World Forum for Harmonization of Vehicle Regulations

Proposal for Supplement 2 to the 09 series of amendments to UN Regulation No. 48 (Installation of Lighting and Light- Signalling Devices)

Submitted by the Working Party on Lighting and Light-Signalling*

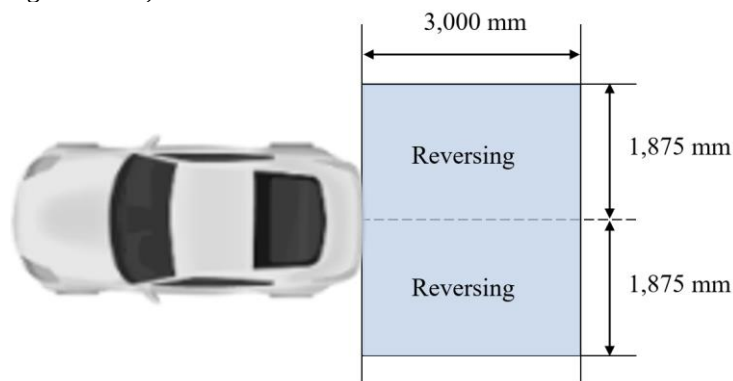
- 6.28.1. Presence
Optional
- 6.28.2. Number
One or two reversing projection(s).
The reversing projector(s) shall be type approved according to the 01 or subsequent series of amendments to UN Regulation No. 148.
- 6.28.3. Arrangement
Such that the provisions of paragraphs 6.28.5., 6.28.6. and 6.28.9. are fulfilled.
- 6.28.4. Position
Such that the provisions of paragraphs 6.28.5., 6.28.6. and 6.28.9. are fulfilled.
- 6.28.5. Projection area
- 6.28.5.1. The lateral distance from the outer edge of the projection with respect to the longitudinal plane of the vehicle shall not be more than 1,875 mm.
The longitudinal distance from the farthest edge of the projection shall not be more than 3,000 mm from the backward extreme outer edge of the vehicle (see figure below).

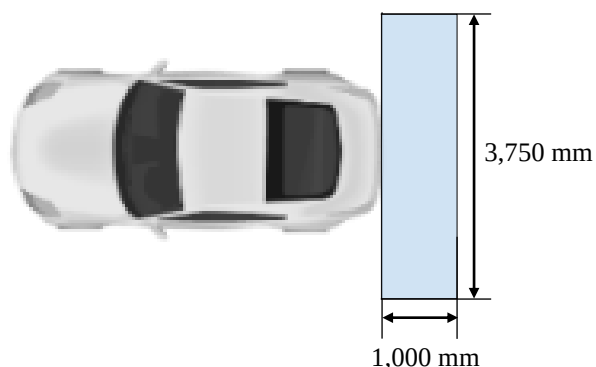
- 6.28.5.2. The patterns of the reversing projections shall start with their closest edge within a rectangle, symmetrical to the median longitudinal plane and adjacent to the extreme outer edge of the vehicle a width of 1,000 mm and a length of 3,750 mm (see figure below).
